MWO 55-1520-241-30-4 \*CHANGE NO. 3

#### REMOVAL OF TWO INLET HOUSING COVER CAPSCREWS

#### **T55 SERIES ENGINES**

### CH-47A, CH-47B AND CH-47C HELICOPTERS

Figure 1. Special Plug.

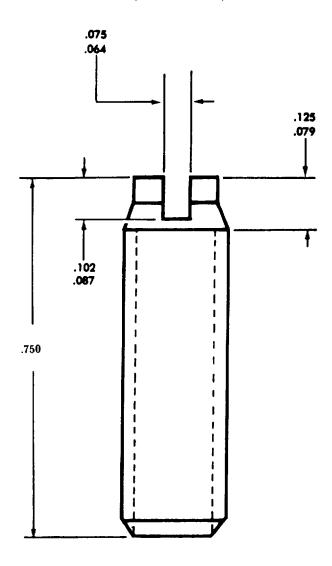
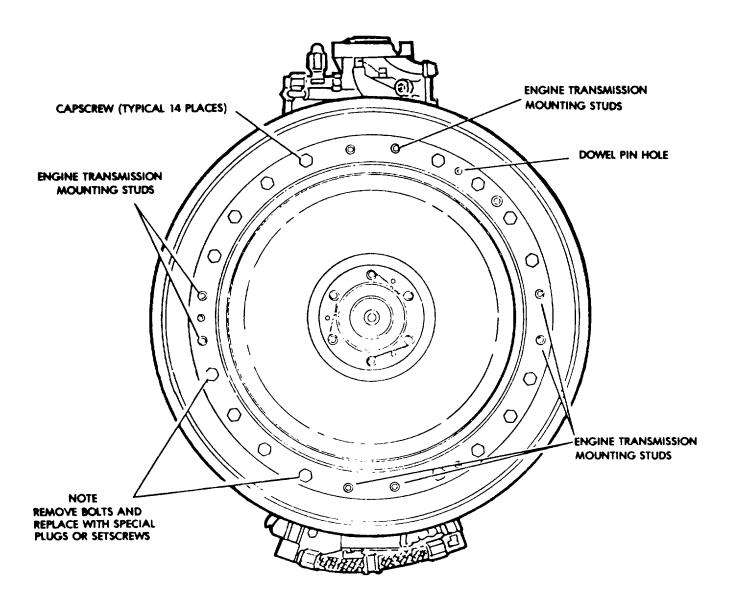
- **a.** Clamp bolt P/N MS9566-12 in bench vise and using a hacksaw, cut head of bolt off at the point where remaining shank length is 0. 750 IN. See figure 1.
- **b.** Using a hacksaw, cut a common screwdriver slot in shank end of bolt to a depth of 0.087 to 0.102 IN. See figure 1.
  - c. Remove all burrs with suitable file.
  - d. Remove previously installed nuts.
  - **e.** Prepare aircraft for safe ground maintenance.
